DEVELOPMENT ASSESSMENT UNIT
Minutes of the Development Assessment Unit
Shire of Augusta Margaret River
On 29 January 2019

DEVELOPMENT APPLICATION ASSESSMENT (DAU)
Report to Manager Planning and Development Services
Proposed Ancillary Dwelling at 11 (Lot 200) Barrett Street, Margaret River

P218670; PTY/1151

Figure 3: Site Plan Extract

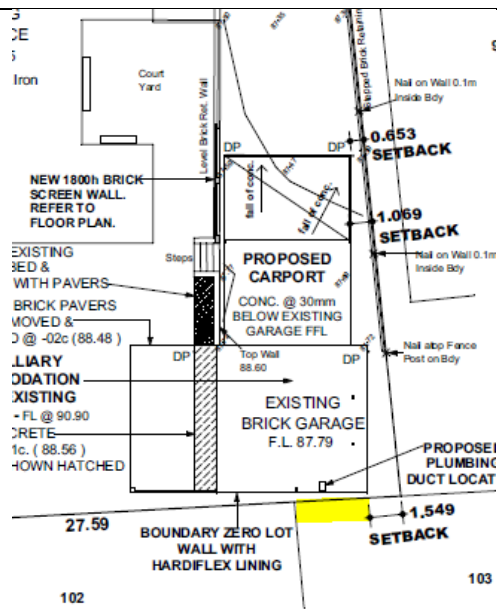
Have agency or authority comments been received?	<input type="checkbox"/> Yes <input checked="" type="checkbox"/> No <input type="checkbox"/> N/A
Nature of Submission	Officer Comment
Objection Proposed addition is intrusive, close to boundaries and unsightly. Bulky and unsightly on my boundary.	The proposal was amended in response to concerns raised during the referral period. Notwithstanding, the amended proposal involves a setback variation to the rear boundary. The proposal would result in a wall up to 5.5m high setback between 110mm and 1 metre to the boundary. While concerns have been raised about the impact arising from this variation, the following is noted: <ul style="list-style-type: none"> - the site for the proposal abuts a shed and a stand of mature vegetation on the rear neighbouring lots (refer to Figure 1); - the proposal would occupy a minor portion (up to 3.8m long portion) of the common rear boundary for each corresponding rear lot noting the boundary of each rear lot is approximately 23m in length (refer to Figure 3);

- neighbouring dwellings to the rear are located over 15 metres from the common boundary; and
- the development site is located at lower ground level to properties at the rear lessening the perceived visual impact of the addition.

- Violation of residential design codes which will create over shadowing of neighbouring backyards, vegetable gardens and fruits trees. Neighbours have spent considerable money to renovate their backyard, which will be overshadowed by this development.

- Concerns with loss of amenity and privacy.

- Design is larger than needs to be, no consideration to setbacks, overshadowing, visual impacts to neighbouring properties. The ancillary dwelling is only 800mm from eastern boundary and 200mm from rear

<p>boundary, both a breach to design codes.</p> <ul style="list-style-type: none"> - The existing garage is incorrectly placed in relation to the property boundaries. To build on top of the garage would compound an already existing breach of the design codes. - Neighbours ground level is 1.2 metres below ground level of proposal. The structure will be approximately 8.3 metres above neighbours ground level. We consider any two (2) storey development to be inappropriate. - Concerns with location of proposed carport only 653mm from boundary, concerns with drainage from concert slab. - Concerns with noise given close proximity and additional vehicle movement. 	<ul style="list-style-type: none"> - Shire records show that the garage was approved in its current location. - The amended proposal involved a reduction in height on the eastern elevation from 5.8 to 5.5 metres. Land in the area slopes from east to west. From site inspections, it is estimated that the eastern neighbouring site is approximately 900mm lower than the development site. The development site abuts existing mature vegetation on the eastern lot which will substantially screen the proposal. Vegetation on adjoining sites is recommended, as a condition of any approval, to be retained and not impacted by construction and excavation phases of the development. - The carport is proposed to be setback 0.653m from the eastern side boundary. The location of the carport meets the deemed to comply standards of the R/Codes. - Concerns about noise given the proximity of the driveway and lack of a boundary fence along the eastern boundary are noted. The R/Codes requires that driveways are located no closer than 0.5 metre from lot boundaries. The side setback of the existing driveway is required to be increased in order to achieve this setback distance. This is recommended to be addressed as a condition of any approval granted. Notwithstanding, the proposal does not show any changes to the existing driveway than the current situation. The driveway would be used to service the additional parking space required for the Ancillary Dwelling however there is no impediment to the location of the current driveway subject to compliance with the 500mm setback.

It is also noted that when assessed against the design principles of the R/Codes, the proposal is considered acceptable with regard to provision of adequate sunlight and ventilation to open spaces on neighbouring sites and minimising overlooking and addressing potential loss of privacy. The R/Codes also provides for buildings to be built up to boundaries where this makes more effective use of space for enhanced privacy for the occupants or outdoor living areas, which is the case with the proposal. The proposal meets the design principles such that it is not considered to have an *'adverse impact on the amenity of the adjoining properties'* in spite of the rear setback variation.

- The proposal meets the deemed to comply standards of the R/Codes in relation to overshadowing at clause 5.4.2. Notwithstanding, the design principles of the R/Codes at clause 5.4.2 specifies that the assessment of a variation to this standard should ensure that main outdoor living areas and north facing major openings to habitable rooms are not impacted. This has been met in the proposal.

- The location of windows and visual privacy are assessed under clause 5.4.1 of the R/Codes. The R/Codes provides specific setbacks from boundaries for windows serving a first floor development. The design of the proposal complies with the required setbacks. The rear elevation does not contain windows or openings. Windows proposed on the eastern elevation are 'minor' openings and are either obscure or high level. Notwithstanding, in response to the concern it is recommended that a condition of approval is applied to ensure that windows facing neighbouring lots are fixed and not able to be opened.

- The proposal was amended as an outcome of the referral period. The eastern side setback was increased from 900mm to 1.5 – 2.2 metres and the wall height was reduced by 300mm. The amended proposal meets the deemed to comply standards of the R/Codes in relation to the eastern side boundary setback. The proposed variation to the rear setback has been discussed earlier in this report.
